# *Officer's Report Proposed District Plan Change 73*

**Suburban Centre Review  
April 2010**

**Wellington City District Plan**

**District Plan Change No. 73**

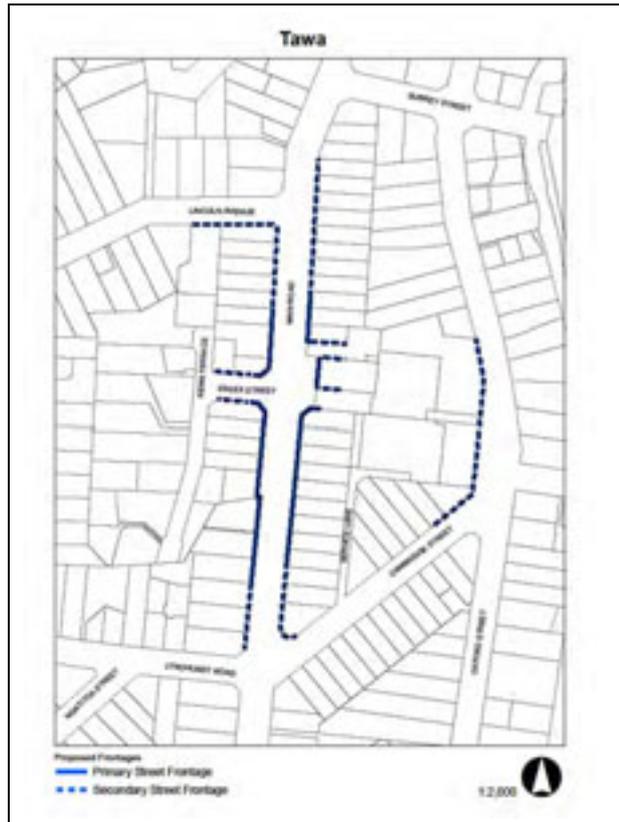
**Submission 103** opposes the identification of the McDonald's restaurant site at the corner of Johnsonville Road and Moorefield Road, Johnsonville, within both a Primary and Secondary Street Frontage. As such, the submission requests that the length of frontage identified as primary street frontage to the McDonald's restaurant site at the corner of Johnsonville Road and Moorefield Road, Johnsonville, on Planning Map 48 be the same as that shown on Planning Map 43 of the Operative District Plan and that the Secondary Street frontage notation on Planning Map 48 be deleted from the Moorefield Road frontage of the site. The submission asserts that the extension of the Primary Street frontage notation, and addition of a Secondary Road notation, imposes unnecessary restrictions on the site and on vehicle access, particularly given that the restaurant and drive through have been established for more than 15 years and the Company's expectation is that it will remain on the site for the foreseeable future.

This site is situated at a pivotal location in the Johnsonville Area. It is highly visible for drivers exiting the Johnsonville motorway off ramp and also acts as a key identifier that the one is entering the Johnsonville Town Centre. Given this key location and the fact that the Johnsonville Road elevation of this site is identified as a frontage on the Operative District Plan, it is not accepted that the proposed frontages should be removed.

*161-163 Karori Road, Marsden Village*

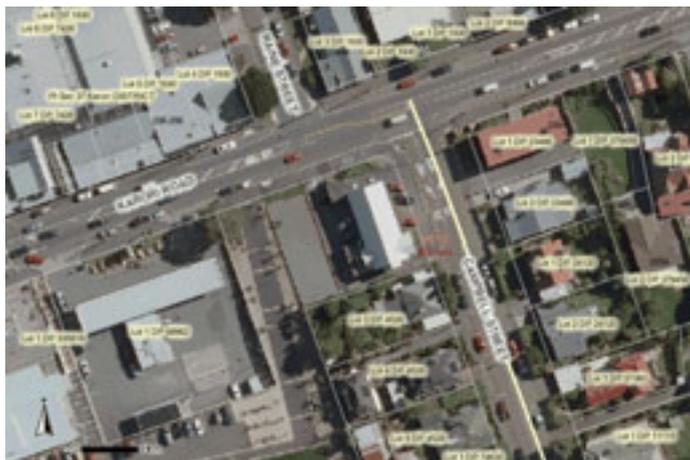
- The site is already positioned well with Marsden Village
- The use of the site is compatible with the Centres zoned and allows for positive community use of the church facilities
- Any redevelopment will be in keeping with the Centres provisions, including the Centres Design Guide
- The rezoning will allow for more flexible use of the site (whilst protecting the interests of adjacent residential properties).

Officers agree with the points made by the submission and recommend that Council proceed to rezone 161-163 Karori Road from Outer Residential to Centres.

<p><i>76-78 Constable Street, Newtown</i></p>	<p><i>Proposed split zoning of 76-78 Constable Street, Newtown</i></p>

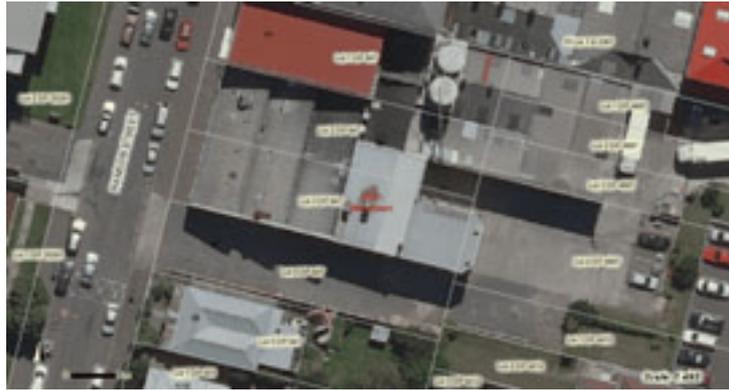
**Submissions 86 and 87** support the proposed rezoning of the site at 76-78 Constable Street, Newtown from Inner Residential to Centres, with an amendment to the width of the part of the site being rezoned. This support and the request the width of the site should be accepted.

*21, 23, 27 and 33 Constable Street, Newtown*

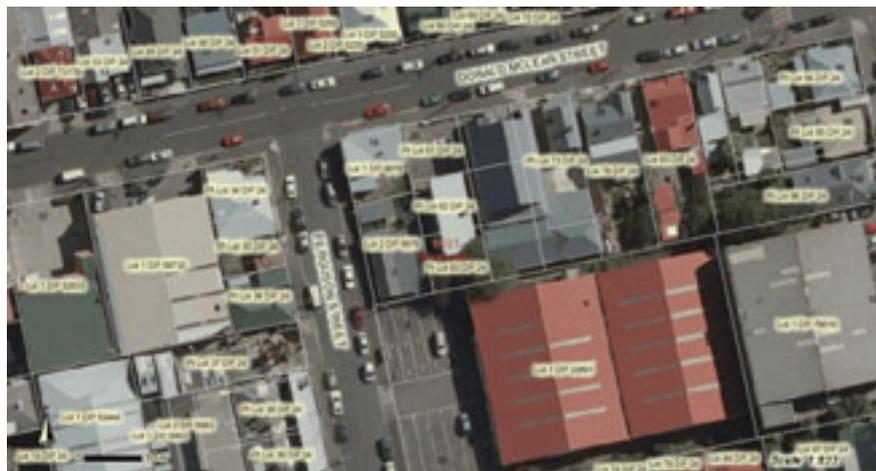
**Submission 60** supports the proposed rezoning of the sites at 21, 23, 27 and 33 Constable Street, Newtown from Inner Residential to Centres. This support should also be accepted.

*Millward Lane, Newtown*

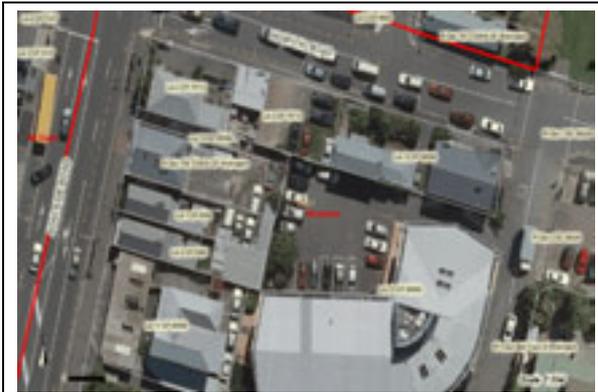
**Submission 59** requests the Council rezone the western side of Millward Lane (in particular 9, 13, 15 and 17) Newtown as Centres to match the existing Centres zoning directly to the east. Millward Lane is a short, dead end pedestrian lane that runs behind the residential properties of 9-19 Millward Street. The car park for McDonalds Restaurant is located immediately to the east and is zoned Centres. Access to the existing houses on the sites is via the rear of the houses off Millward Street. The actual frontage of the properties is eastwards overlooking the McDonalds car park. An additional household unit has been built on the rear of 11 fronting the lane. It would appear that the rezoning is sought to enable the sites to be redeveloped without providing carparking.

Officers do not support the re-zoning of the land to Centres. The fronts of these sites are not able to be serviced by vehicles, and a Centres zoning would permit a wide range of uses on these sites that may not be compatible with surrounding residential activities. For this reason, Officers recommend rejecting this submission.
